NOTICE TO USERS OF ALADDIN KEROSENE MANTLE LAMPS MODELS A & B

NOTE: These drawings illustrate the new Model "C" Burner.

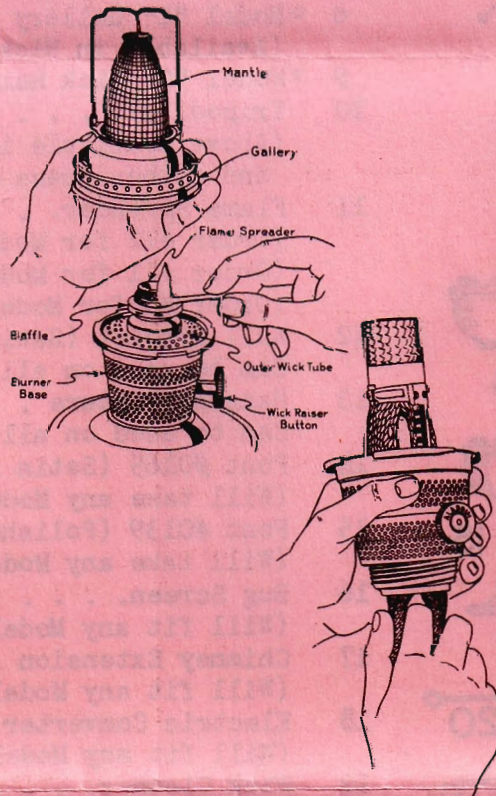
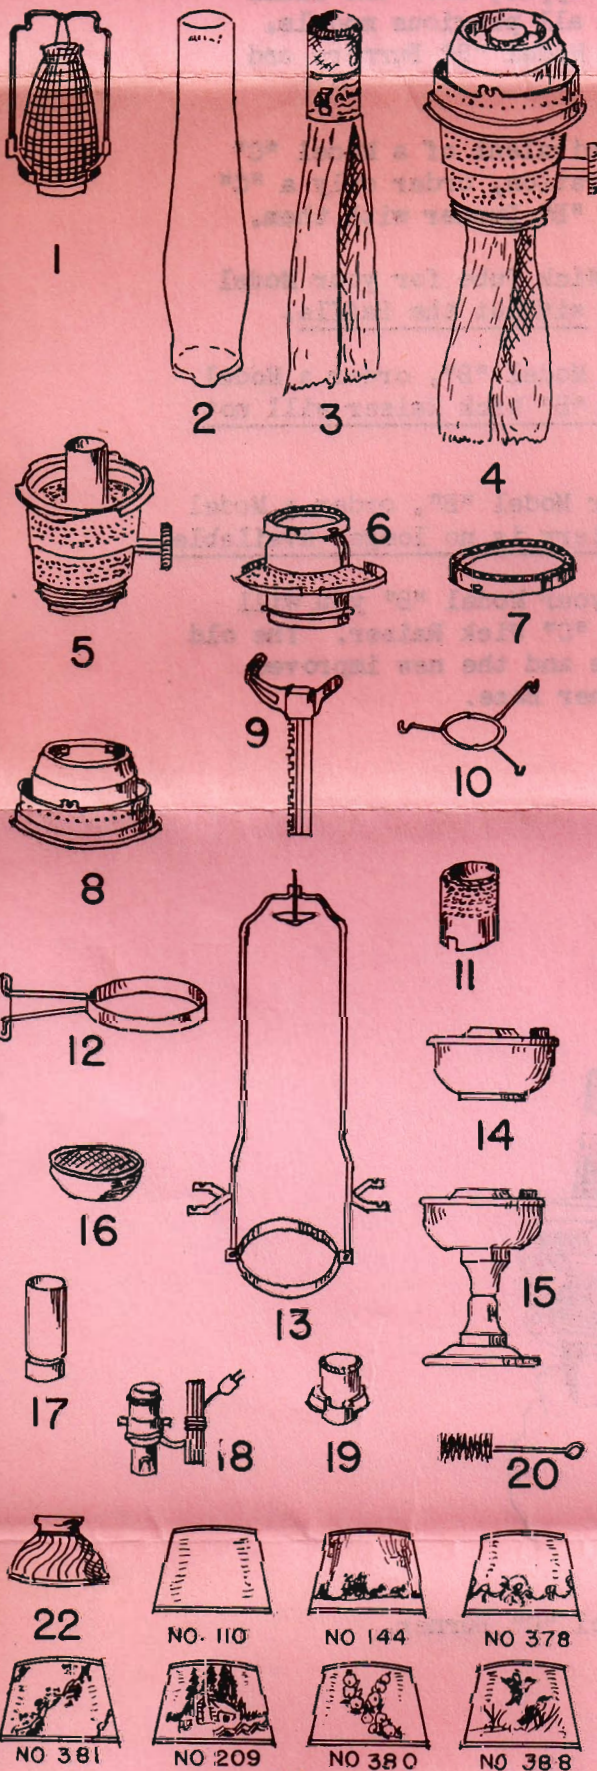
It has several very important advantages over older types. The greatest of these is its ability to remain cooler in operation - thus making it far more reliable than older types; ie: the flame will not "creep up" to the extent it did in all previous models. We have discontinued the manufacture of all Model "B" Burners and Model "B" Burner parts.

To convert your present Model "B" to the equivalent of a Model "C" and get the advantages of more reliable operation, order only a "C" Baffle and "C" Gallery and equip your Model "B" Burner with them.

However, if ever you need only a new Outer Wick Tube for your Model "B", order only a Model "C" Outer Wick Tube without the Baffle.

If ever you need only the Burner Base for a Model "B", order a Model "C" Burner Base and a "C" Wick Raiser. The "B" Wick Raiser will not fit the new improved "C" Burner Base.

If ever you need only a new Gallery for your Model "B", order a Model "C" Gallery with a "C" Baffle. The "B" Gallery is no longer available.

Should ever you need a new Wick Raiser for your Model "B" you will have to order a Model "C" Burner Base and a "C" Wick Raiser. The old style "B" Wick Raiser is no longer available and the new improved "C" Wick Raiser cannot be used in a "B" Burner Base.
